## **New Zealand Transport Agency**

Whirokino Trestle and Manawatu River Bridge Specimen  
Design Road Safety Audit

July 2017

**Figure 2: Embankment Shoulder Delineation Treatments**

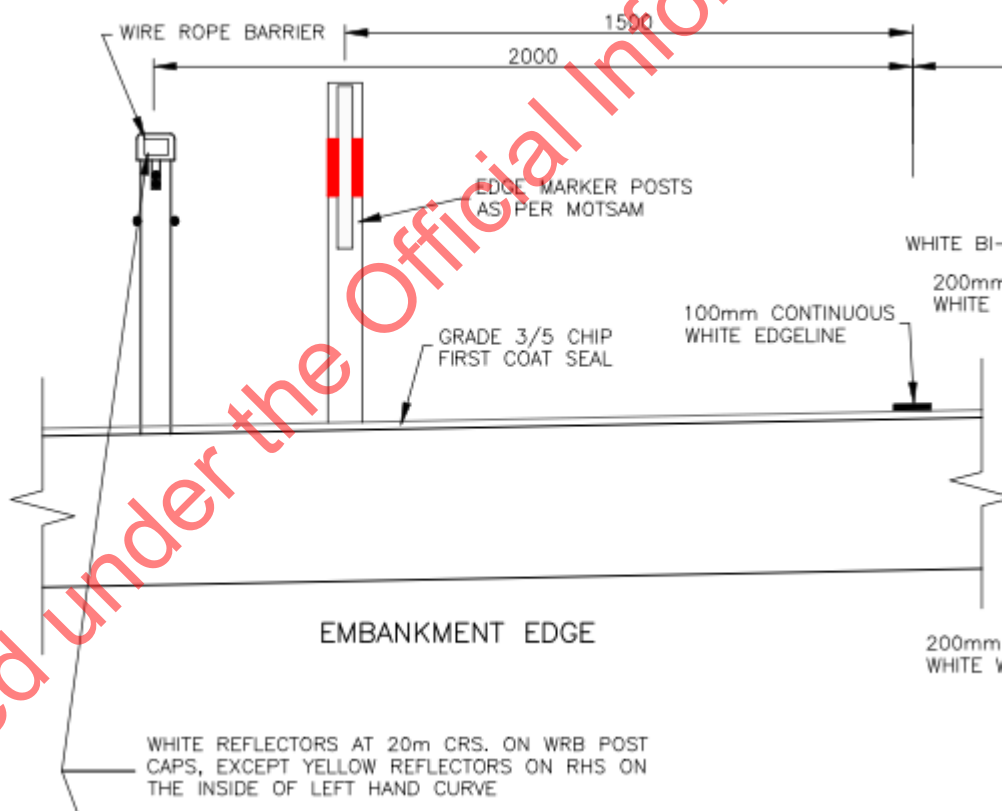
Edge marker posts have been included on the embankment sections of the new alignment located 1.5 m from the edgeline, and 0.5 m from the wire-rope edge barriers as shown in Figure 2 below; it should be noted that Figure 2 does not include planned edgeline ATP marking. Edge marker posts at this location are a hazard/obstruction to road users on the shoulder such as confident cyclists and hinder and increase required maintenance activities.

Include edge marker posts as an attachment on the outside of the wire-rope barriers.

Designer Response	We agree with the audit recommendations because otherwise the edge marker posts at 1.5m offset negate some of the benefits of providing a
-------------------	---

2.0m wide shoulder.
Safety Engineer	Support the auditors' and designers', recommendation.
Client Decision	<b>Agree with the Safety Engineer's response.</b>
Action Taken	The current Principal Supplied Design incorporates the Client Decision to move the EMP's behind the barrier. No further action is required.
